Agenda Item #: 11

SUB-002538-2023 & MOD-002570-2023

EBM Midtown Subdivision, Resubdivision of Lot A

- Subdivision approval to create two (2) legal lots of record
- Modification of a previously approved Planned Unit Development

SITE PLAN

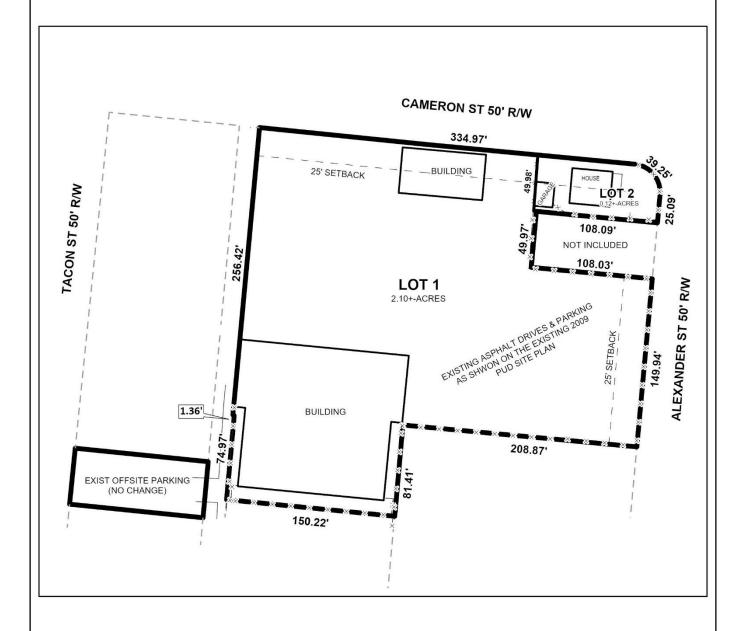
A 25-foot front yard setback is illustrated along Cameron Street and Alexander Street, but only a 10-foot front yard setback is required for lots in a B-2, Neighborhood Business Urban District, per Article 2 Section 64-2-13.E. of the Unified Development Code (UDC). The applicant may retain the 25-foot setback, but if approved and the plat recorded in Mobile County Probate Court depicts a 25-foot front yard setback, future development of the properties will be subject to a front yard setback greater than what is required by the UDC. As such, at least a 10-foot front yard setback should be illustrated along Cameron and Alexander Streets on the Final Plat, if approved.

Both lots are developed with buildings that encroach within required front, side, and/or rear yard setbacks. A garage is also depicted on proposed Lot 2 and meets the required setbacks for a B-2, Buffer Business Urban District; however, aerial photos and Google Street View images show that an unenclosed carport was added to the garage sometime after 2010 and it encroaches on the required 10-foot front yard setback. The encroachments can be approved by the Planning Commission via the modified PUD site plan, but it should be noted that because of the reduced setbacks, approval of the subdivision will be contingent upon approval of the modified PUD. If approved, the plat should be revised to illustrate the existing garage with carport addition.

The site plan provided reflects the changes proposed by the associated Subdivision request, and includes the size of each proposed lot in square feet and acres. Both lots, as mentioned, are developed and contain one (1) or more buildings that encroach on the required 10-foot front yard setback. Furthermore, as mentioned, an unenclosed carport on proposed Lot 2 extends into the required front yard setback. As such, the site plan should be revised to illustrate the existing garage with carport addition.

- 2. Retention of at least the 10-foot minimum building setback line along Cameron Street and Alexander Street, as required by Section 64-2-13.E. of the Unified Development Code;

- 3. Revision of the site plan to illustrate the existing garage with carport addition;
- 4. Revision of the site plan to illustrate compliance with the conditions of approval for rezoning ordinance 64-044 (adopted June 18, 2022 by the Mobile City Council), or provision of a note on the recorded site plan stating the site must comply with the rezoning conditions;
